**SAR Train A & B Blower Replacement
 BID PHASE - CLARIFICATION No. 1
 CLMC 573**

CIP Project No. 3333.028
 IFB: 6100 CLMC 573

The following are answers to Bidders received on the above project. These answers do not modify the Contract. Any modifications to the Contract will be through Addenda.

Reference drawing for elevation views on following page.

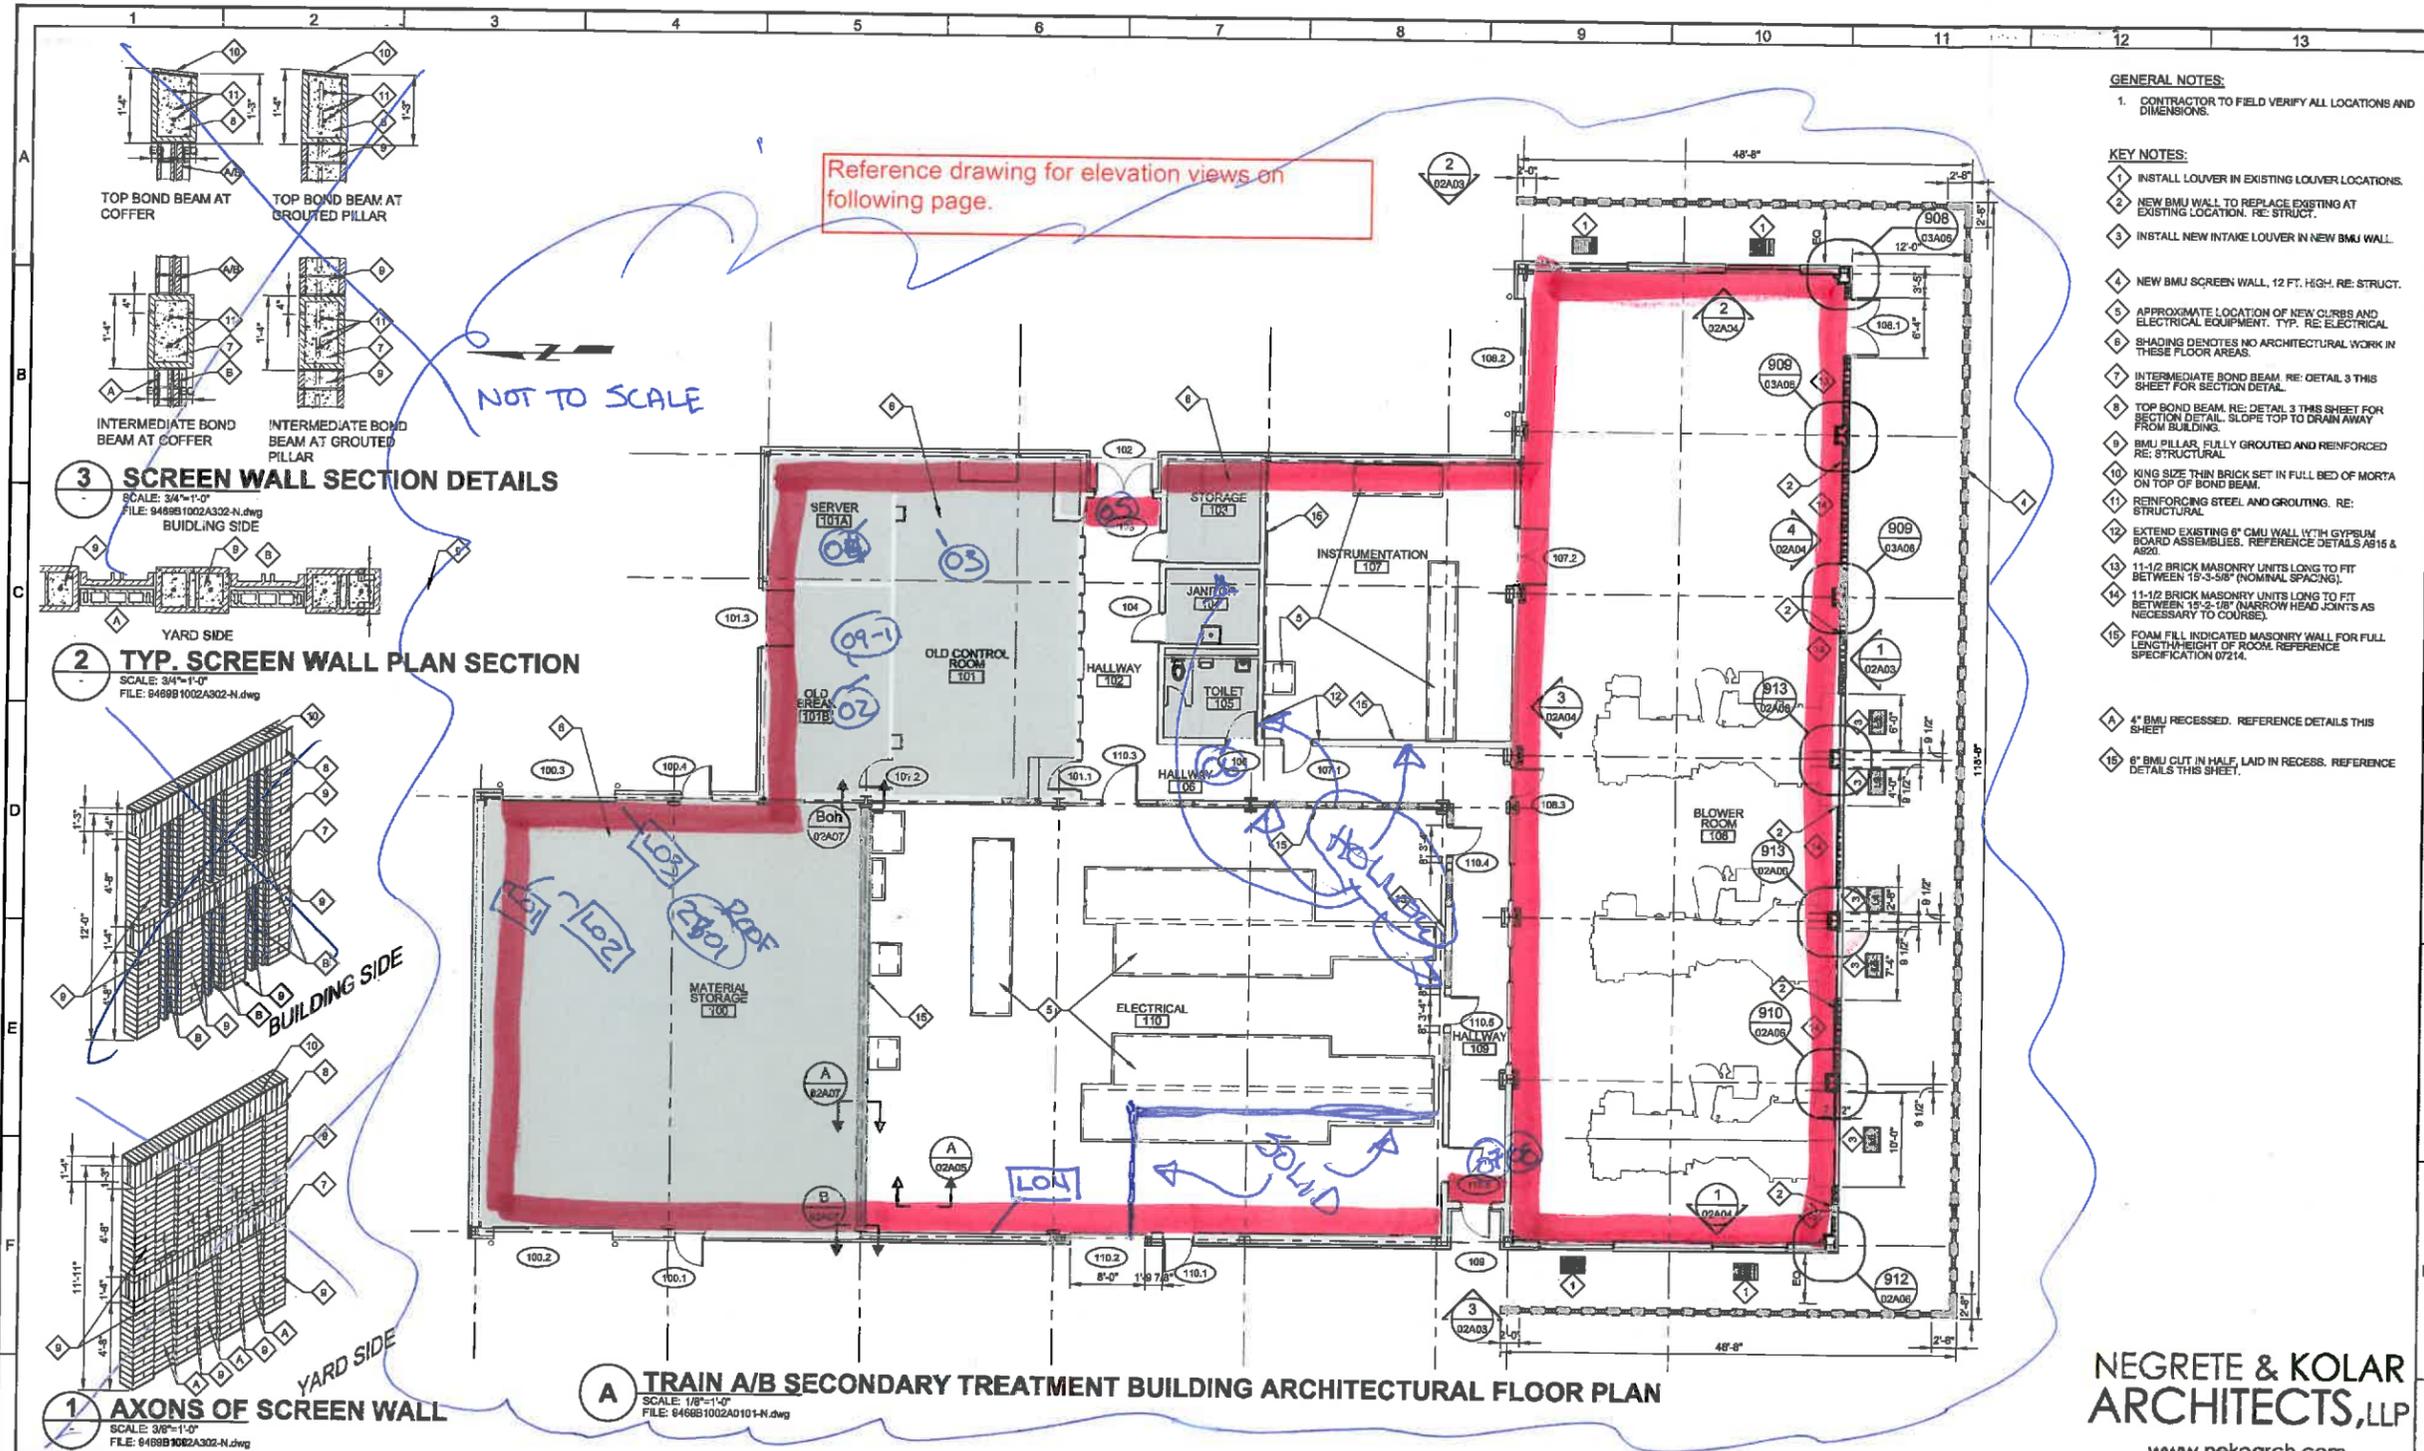
34	Clarification: Wage Rate Determination	See attached Wage Compliance Analysis for additional information regarding allowable wage rates.
35	Clarification: Train A/B Secondary Treatment Building walls containing insulation with Asbestos	See attached plan for additional information regarding which walls in the Secondary Treatment Building are known to contain insulation with an Asbestos component.
36	Specification Para. 2.03.B.4.a is clear that Sch. 80 PVC manifolds are required. However, the drawings show Sch. 40 PVC pipe required downstream of the SS drop pipes. Ref. 03M04.	The drawings should not call out the pipe schedule, only the material as PVC. Follow the manifold material called out in the diffuser specification (Sch. 80 PVC).
